Subject: MHI's Response to US-APWR DCD RAI No. 633-4857 Revision 0

Response to Request for Additional Information No. 633-4857
Revision 0

US-APWR Design Certification

RAI NO.: NO. 633-4857 REVISION 0
SRP SECTION: 09.01.04 – LIGHT LOAD HANDLING SYSTEM (RELATED TO REFUELING)
APPLICATION SECTION: 09.01.04
DATE OF RAI ISSUE: 09/17/2010

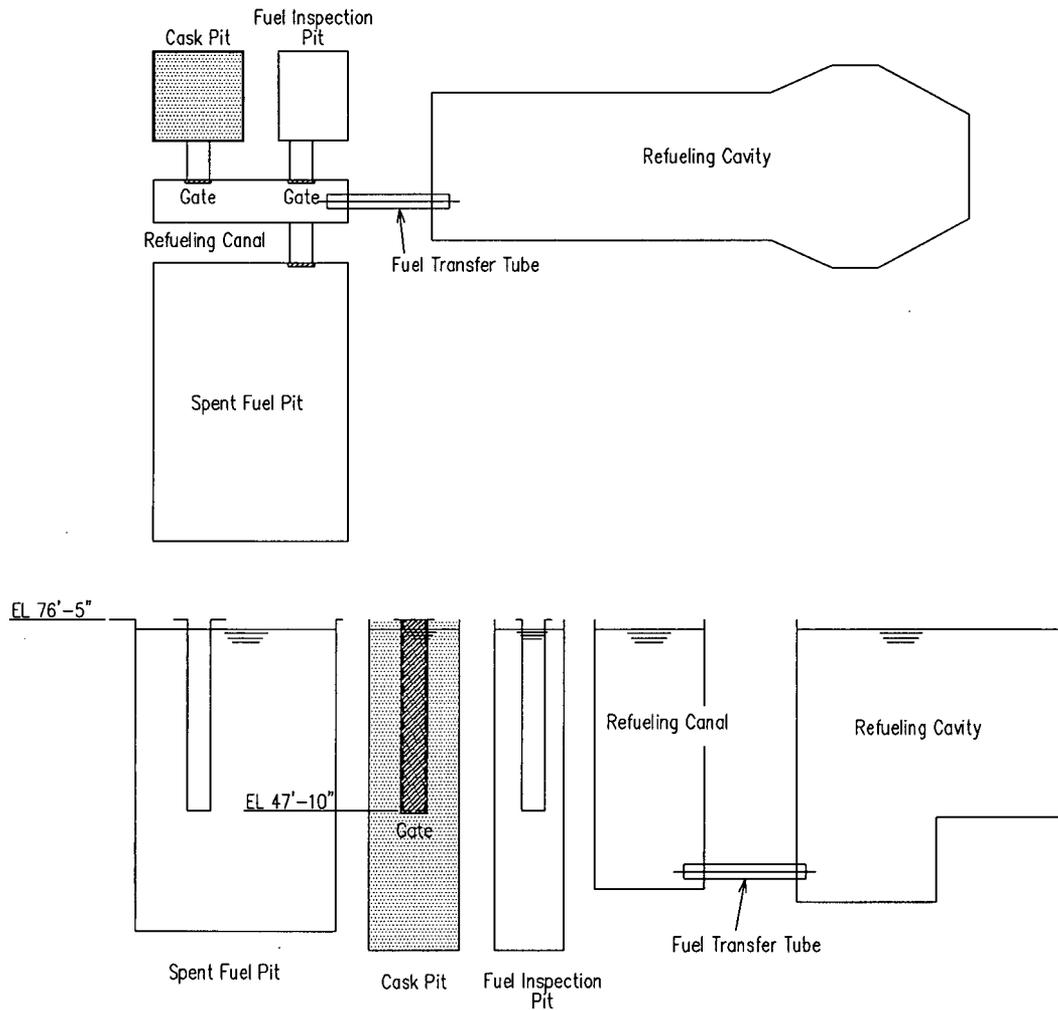
1. The response indicated that the permanent cavity seal (PCS) is a stainless structure that is permanently attached to both the reactor vessel flange and the refueling cavity floor with both bolted joints and welds. The response included a figure to show the PCS, but it did not indicate where the welds are located or how the bolted joints are sealed to prevent leakage. The DCD also needs to explain/specify:
 - a. if the seal is treated as a structure or mechanical component,
 - b. codes or standards that apply to the seal assembly,
 - c. codes/standards that apply to welds, and distinction between shop vs. field welds, and
 - d. why catastrophic failure of welds will not occur.

Additional information regarding the permanent cavity seal is provided as follows:

- a) The PCS is treated as a mechanical component.
- b) Material selection and seal manufacture are performed in accordance with the appropriate ASME criteria or criteria recommended by the manufacturers.

- c) Welding is performed in accordance with appropriate ASME criteria. Segments of the PCS are assembled by welding the fixed parts and segments of the seal plates on both ends. The segments are shaped into a ring by welding one another at the shop or on-site depending on transportation conditions for a specific site. The ring of the PCS is fixed on the reactor vessel flange and refueling cavity floor with bolts, and seal welding is performed around the PCS and the bolts to ensure on-site seal performance.

- d) The integrity of the PCS is confirmed through evaluation in terms of fatigue caused by thermal stress over the life of the plant, and strength against water pressure during refueling operation. Since the PCS is protected by the lid against an accidental fuel drop, catastrophic failure of the welds will not occur.

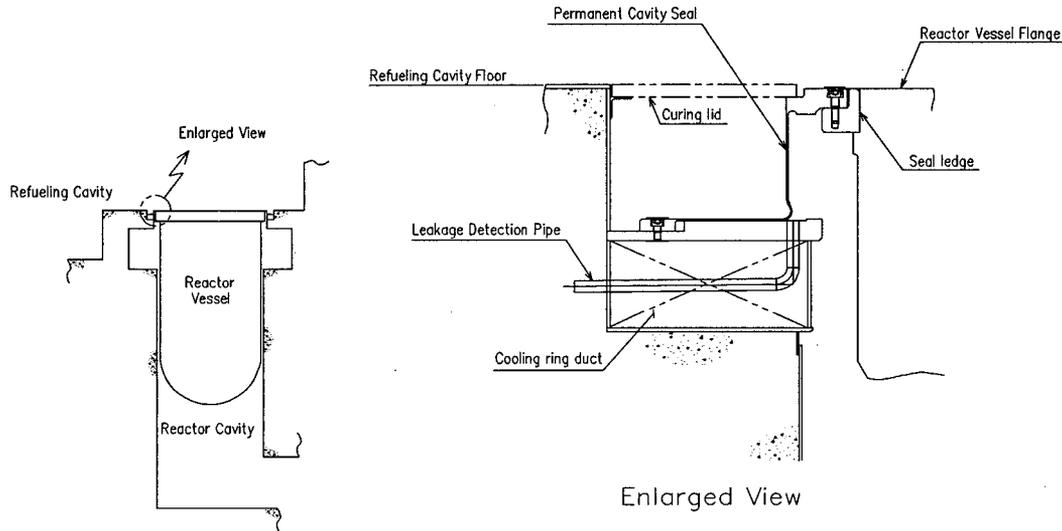
2. Item (a) of the RAI requested the applicant to provide information concerning the PCS and any other seals that will be used and whose failure could cause the refueling cavity to drain. Except for the PCS and seals on the cask pit and fuel inspection pit gates, other seals and plugs that fit this description were not described in the response. For example, seals that are typically installed in the steam generator hot leg and cold leg nozzles to facilitate inspection and repair activities were not described. Additional information is also needed to explain how leakage through the

seals on the cask pit and fuel inspection pit gates will cause the refueling pit to drain down (i.e. diagrams showing relative elevations and flow paths need to be provided).

Regarding the leakage through the seal on the cask pit and the fuel inspection pit gates, the relative elevation of the bottom of the pit gate, refueling cavity, and other structures are shown in the figure below. The cask pit has no water during refueling operation and is isolated from the refueling canal with a gate. If unexpected leakage from the gate occurs, the water flows from the refueling cavity, refueling canal and spent fuel pit into the cask pit through the gate.
